**Nine Mile Point
Nuclear Station**

**SUBJECT: Nine Mile Point Unit 2
Docket No. 50-410
Facility Operating License No. NPF-69**

**License Amendment Request: Revise Standby Liquid Control System Sodium
Pentaborate Solution Requirements, Technical Specification 3.1.7**

Figure 3.1.7-1 (Page 1 of 1)
Sodium Pentaborate Solution Volume/Concentration Requirements

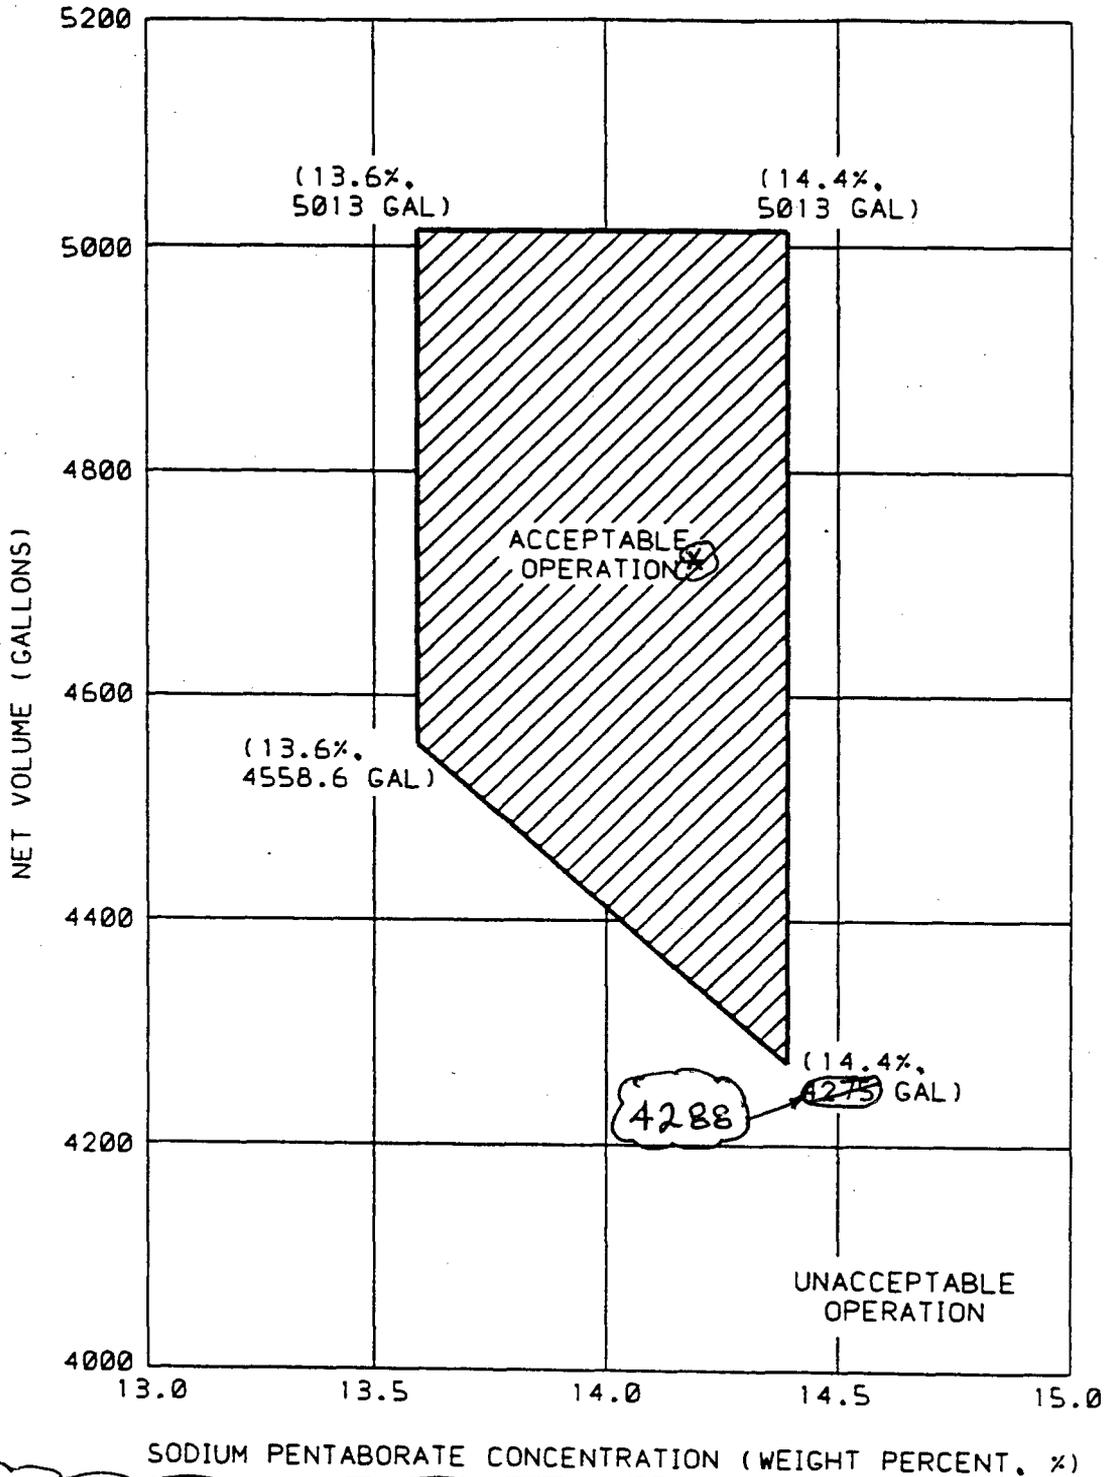
NMP2 TS SR 3.1.7.1 and SR 3.1.7.5 require that the available volume and concentration of sodium pentaborate solution in the SLC tank be within the limits of TS Figure 3.1.7-1. Figure 3.1.7-1 consists of a graph that defines acceptable SLC tank volume and concentration values, such that the required boron concentration in the reactor core will be achieved. The proposed change revises Figure 3.1.7-1 by adding a notation regarding the required Boron-10 enrichment, consistent with the proposed new SR 3.1.7.10. In addition, a minor adjustment is being made to one of the coordinates that define the Acceptable Operation region of Figure 3.1.7-1. The current concentration/volume coordinate of 14.4 percent/4275 gallons is changed to 14.4 percent/4288 gallons. This adjustment resulted from different roundoff techniques utilized in the prior volume calculation versus the present calculation.

The current versions of Technical Specifications pages 3.1.7-3 and 3.1.7-4 (Figure 3.1.7-1) have been marked-up by hand to reflect the proposed changes.

* For Boron-10 Isotope Enrichment ≥ 25 Atom Percent

SR 3.1.7.10 Verify sodium pentaborate enrichment is ≥ 25 atom percent B-10. Prior to addition to SLC tank
